VIRGINIA ELECTRIC AND POWER COMPANY
RICHMOND, VIRGINIA 23261

Serial No. 03-183
NL&OS/ETS
Docket Nos. 50-338/339
50-280/281
License Nos. NPF-4/7
DPR-32/37

VIRGINIA ELECTRIC AND POWER COMPANY
NORTH ANNA POWER STATION UNITS 1 AND 2
SURRY POWER STATION UNITS 1 AND 2
REQUEST FOR ADDITIONAL INFORMATION ON
TOPICAL REPORT VEP-FRD-42, RELOAD NUCLEAR DESIGN METHODOLOGY

NORTH ANNA UNIT 1 - CYCLE 16 STARTUP PHYSICS TESTS
ASSEMBLYWISE POWER DISTRIBUTION
29% POWER

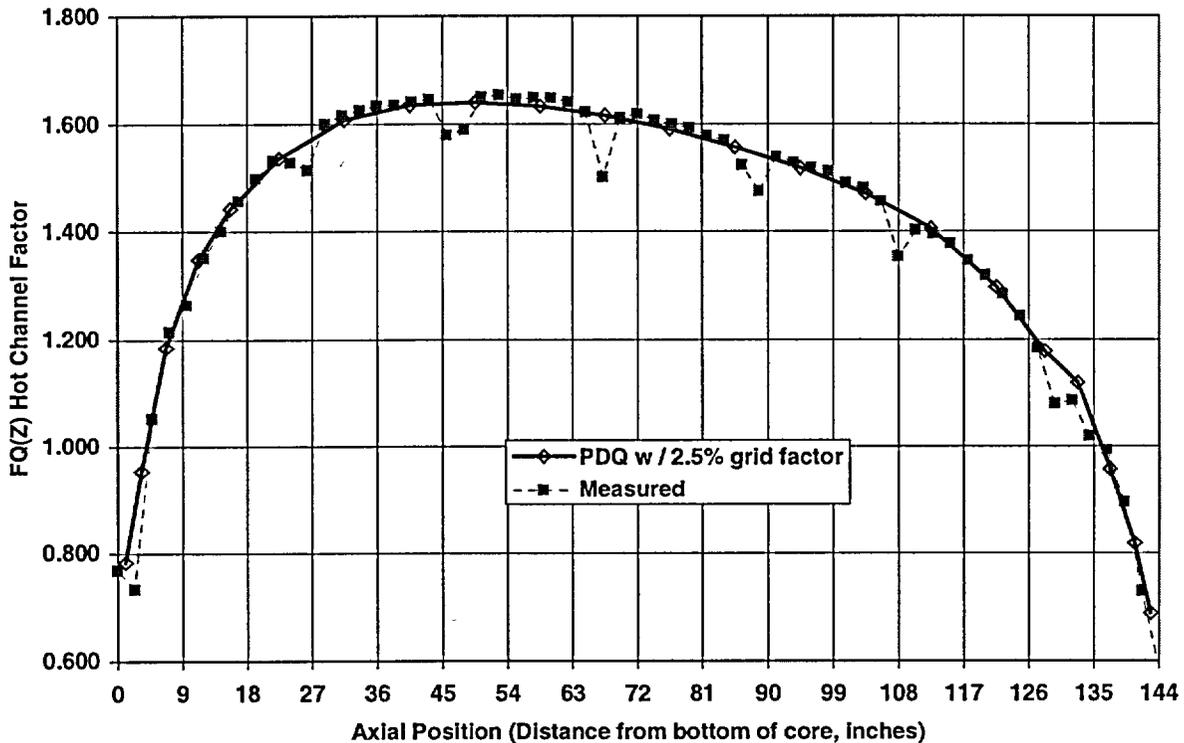
1. By letter dated December 2, 2002, VEPCO stated that the accuracy of the PDQ model is verified each cycle during startup physics testing and during routine core follow. Please provide representative results from a recent refueling outage (comparisons between the startup physics test data and the PDQ predictions) that demonstrate the accuracy of this model.

DOMINION RESPONSE TO QUESTION 1

N1C16 HZP BOC B-Bank Differential Worth

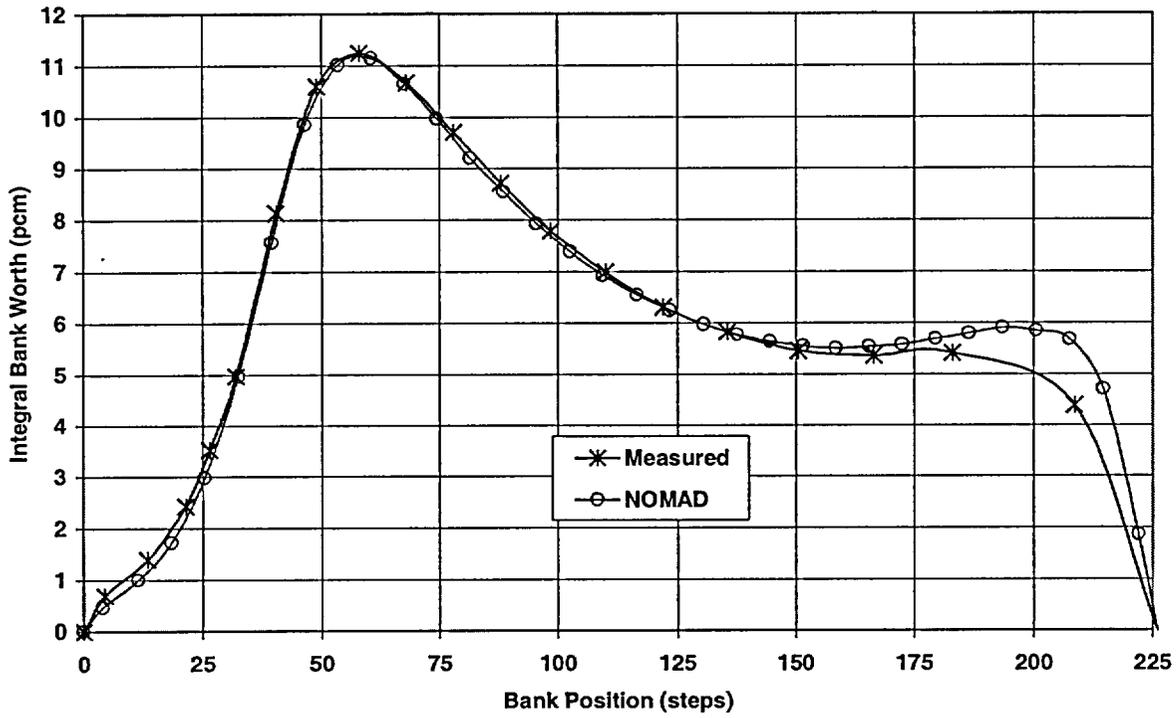
By letter dated December 2, 2002, VEPCO stated that the accuracy of the NOMAD model is verified each cycle during startup physics testing and during routine core follow. Please provide representative results from a recent refueling outage (comparisons between the startup physics test data and the NOMAD predictions) that demonstrate the accuracy of this model.

Verification of NOMAD accuracy comes primarily by extension through comparison to PDQ Two Zone model (Topical Report VEP-NAF-1) predictions during the NOMAD model setup process (see also the response to questions 3 and 7). The NOMAD model setup procedure provides specific power distribution and reactivity acceptance criteria for these comparisons that must be met. There are, however, a few direct comparisons to startup physics test data that can be made. The following results are from the N1C16 startup physics tests in October 2001.
